2018 Project Review Sheet (2019 Construction)

Project #	18-725
Project Title:	Crossing Improvements on Western Ave & Lenora/Blanchard
Location:	First Curb bulb in on the SW corner of Western Avenue and Lenora, on Lenora. The second curb bulb isn on the SW corner of Western Avenue and Blanchard, on Blanchard. There is a curb bulb on the SW corner of Western and Blanchard, but it is one Western,

YVYC 2018: 18-725, Western Ave & Lenora and Blanchard

Figure 1: Proposed Improvements at Western Ave and Lenora St

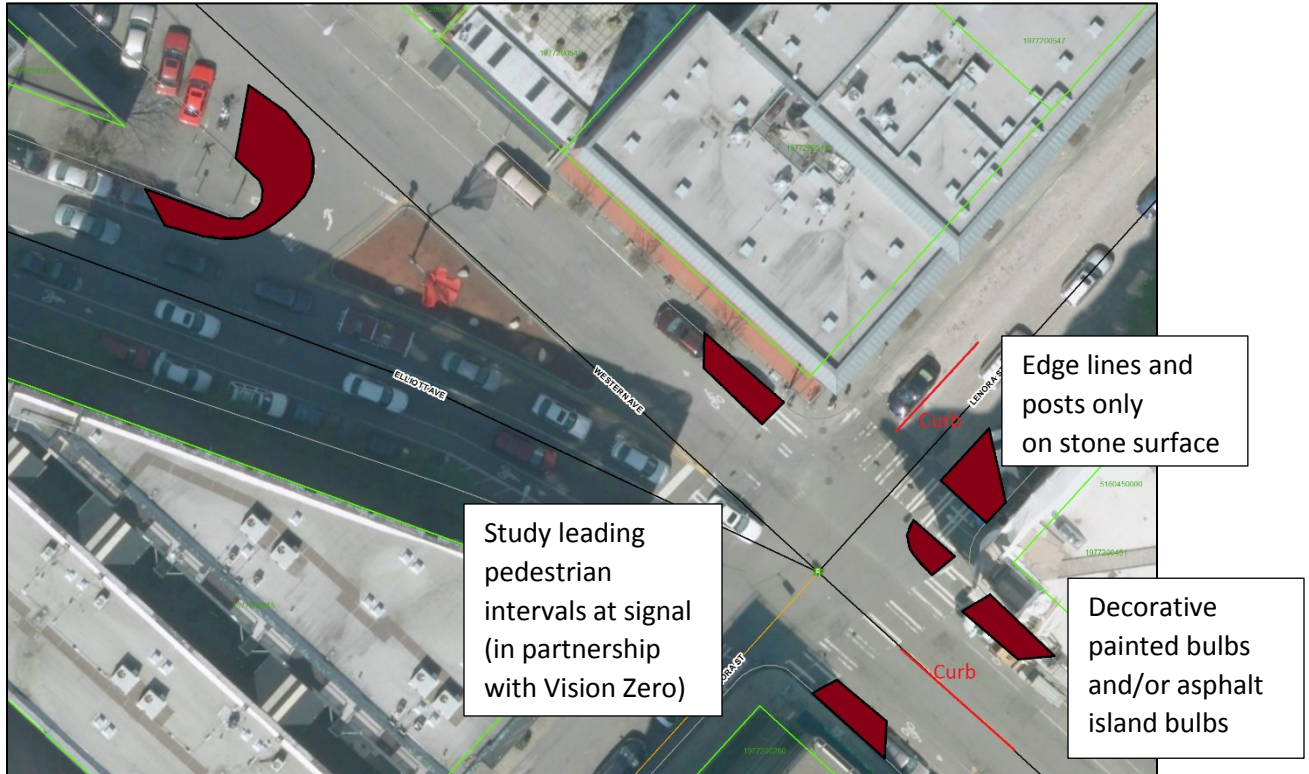
Comments: Due to the budget of the YVYC program, and the existing site conditions, full curb bulbs are not feasible. SDOT recommends installing paint-and-post bulbs at both intersections, on all corners of Western Avenue and Blanchard Street and the north, east, and south corners of Western Avenue and Lenora Street.

SDOT recommends installing paint-and-post curb bulbs (or asphalt island bulbs, depending on funding) at the intersections of Western Avenue and Lenora Street and Western Avenue and Blanchard Street. The bulbs will shorten the crossing distance for pedestrians, help slow traffic, and enforce the default parking restrictions within 20 feet of an intersection, and 30 feet of a stop sign. In partnership with the Vision Zero program, SDOT will study installing leading pedestrian intervals (where pedestrians get the walk sign a few seconds before drivers get the green light) at Western Avenue and Lenora Street, and installing curbing along the centerline of Western Ave south of Lenora Street as well as Lenora St east of Western Ave, to slow turning vehicles. Depending on costs, the existing vehicle signals at Western and Lenora may be replaced to meet current standards. Additionally, the centerline on Western Avenue between University and Lenora Streets will be changed to a no passing, double solid yellow, center line.

Install no-pass centerline on Western Ave south to University St
